Location of Construction: 25 Caldwell Street		Owner: Thomas and MaryAnn Connolly		Phone: 772-5736		Permit No: 960283	
Owner Address:		Leasee/Buyer's Name:		Phone:		BusinessName:	
Contractor Name: Larry Pallozzi		Address:		Phone:		<div style="border: 2px solid black; padding: 5px; text-align: center;"> PERMIT ISSUED Permit Issued: APR 23 1996 CITY OF PORTLAND </div>	
Past Use: Single family dwelling		Proposed Use: single family dwelling w/ addition		COST OF WORK: \$ 25,000.00 PERMIT FEE: \$145.00 FIRE DEPT. <input type="checkbox"/> Approved <input type="checkbox"/> Denied INSPECTION: Use Group: 43 Type: 50 30 CA 43 Signature: <i>[Signature]</i>			
Proposed Project Description: Addition as per plans		PEDESTRIAN ACTIVITIES DISTRICT (P.A.D.) Action: Approved <input type="checkbox"/> Approved with Conditions: <input type="checkbox"/> Denied <input type="checkbox"/> Signature: _____ Date: _____		Zoning Approval: <i>[Signature]</i> Zone: <input checked="" type="checkbox"/> 176-L-L CBL: <i>[Signature]</i> Special Zone or Reviews: <input type="checkbox"/> Shoreland <input type="checkbox"/> Wetland <input type="checkbox"/> Flood Zone <input type="checkbox"/> Subdivision <input type="checkbox

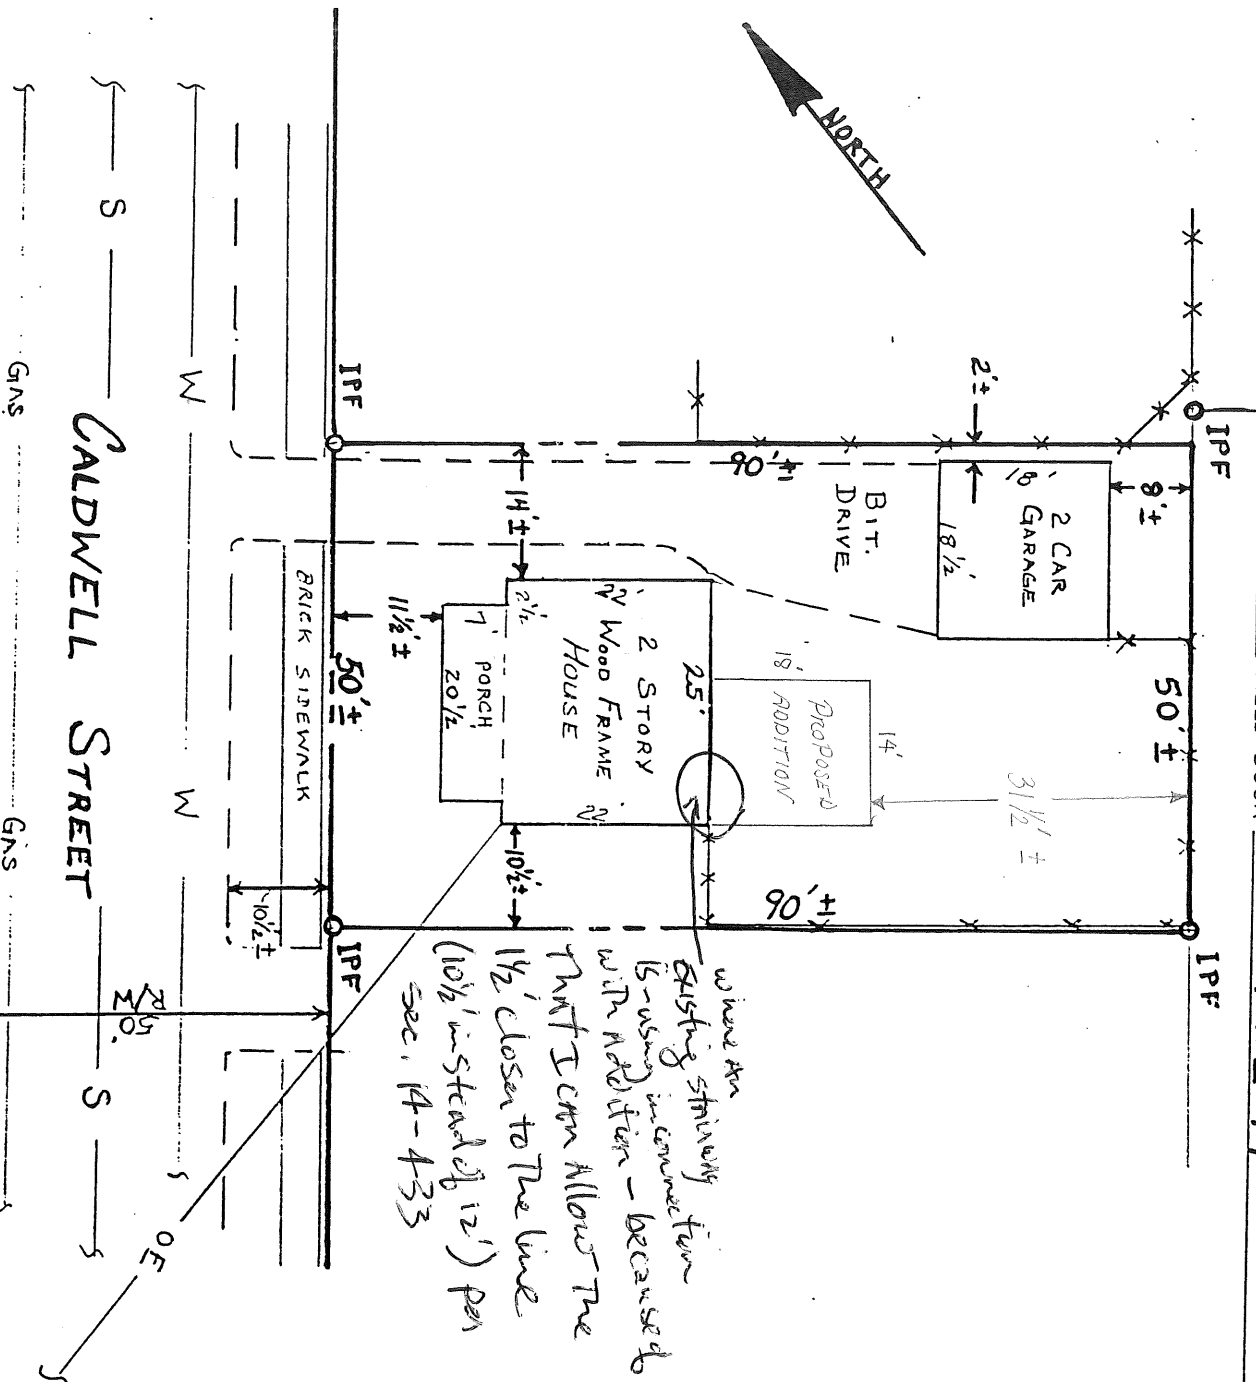
Rear Yards - 20' req - 3 1/2' shown

→ Side Yards - 12' req for 2 stories - 10 1/2' shown

where an existing driveway is being incorporated with addition - because that I can allow the 1 1/2' closer to the line (10 1/2' instead of 12') per sec. 14-433

(Note!) Under Section 14-433 of Land Use, I can't Am allowing 10 1/2' to the lot line rather than 12' for 2 stories - The owners have shown me that it would be unreasonable because of the interior stairway to inset the bldg.
